UNITED STATES PATENT AND TRADEMARK OFFICE

Office Action Summary

09/733,104

DETAILED ACTION

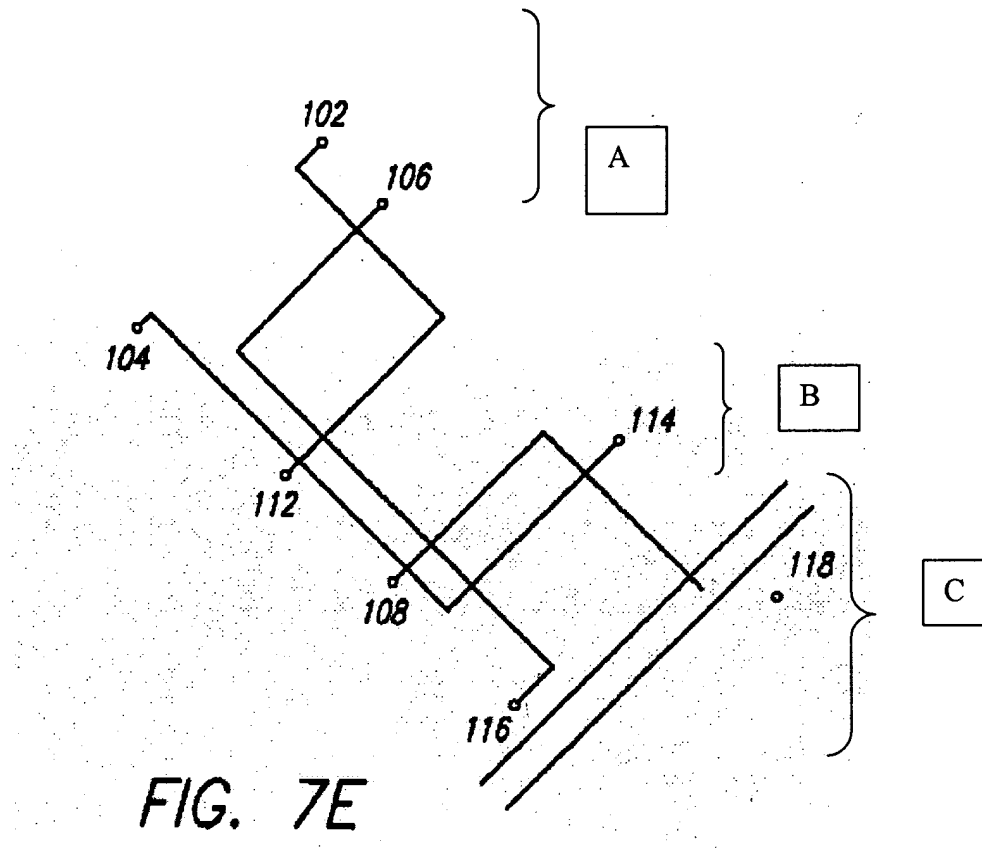
2. The drawings are objected to under 37 CFR 1.83(a). The drawings must show every feature of the invention specified in the claims. Therefore, the following phrases “the second section further comprising at least one conductor deposited in a Manhattan direction coupled to a

conductor deposited in said preferred diagonal wiring direction” and “the first section further comprising at least one conductor deposited in a diagonal direction coupled to a conductor deposited in the Manhattan wiring direction” must be shown or the feature(s) canceled from the claim(s). No new matter should be entered.

Applicant argues “applicants respectfully submit that the drawings do show both these features. For instance, Figure 10 illustrates a section 1010 of metal layer 1000 that includes a Manhattan line 1012 (in this case a horizontal line) connected to a conductor in the preferred diagonal direction of the section 1010. In addition, Figure 14 illustrates interconnected horizontal and diagonal wiring.” This argument is not persuasive. First, applicant does not clearly redefine the claim term “Manhattan or Manhattan wiring direction” in the rejected claims that the Manhattan or Manhattan wiring direction is a horizontal line direction. Second, applicant should note that the usual meaning of the term “Manhattan” is a rectangular or right-angle rectilinear.

Since Fig. 10 and Fig. 14 are not illustrated the rectangular or right-angle rectilinear line coupled to a conductor deposited in the preferred diagonal wiring direction, the objection to the drawings is maintained.

In claim 1, the specification fails to disclose the **second section** further comprising at least one conductor deposited in a **Manhattan direction** coupled to a conductor deposited in said preferred diagonal wiring direction.

Applicant argues “applicants respectfully submit that the drawings do show both these features. For instance, Figure 10 illustrates a section 1010 of metal layer 1000 that includes a Manhattan line 1012 (in this case a horizontal line) connected to a conductor in the preferred diagonal direction of the section 1010. In addition, Figure 14 illustrates interconnected horizontal and diagonal wiring.” This argument is not persuasive. First, applicant does not clearly redefine the claim term “Manhattan or Manhattan wiring direction” in the rejected claims and set forth the uncommon definition so as to put one reasonably skilled in the art on notice that the applicant intended to so redefine that claim term that the Manhattan or Manhattan wiring direction is a horizontal or vertical line direction. Second, applicant should notes that the usual meaning of the term "Manhattan" is a rectangular or right angle rectilinear and a non rectangular or none right angle rectilinear is called “non-Manhattan”. The wiring in Fig. 10 and Fig. 14 are non-Manhattan wirings. Thus, Fig. 10 and Fig. 14 are not illustrated Manhattan wirings, that has rectangular or right angle rectilinear line, coupled to a conductor deposited in the preferred diagonal wiring direction, the rejection is maintained.

A proposed drawing correction or corrected drawings are required in reply to the Office action to avoid abandonment of the application. The objection to the drawings will not be held in abeyance.

3. Applicant is required to submit a proposed drawing correction in reply to this Office action. However, formal correction of the noted defect may be deferred until after the examiner has considered the proposed drawing correction. Failure to timely submit the proposed drawing correction will result in the abandonment of the application.
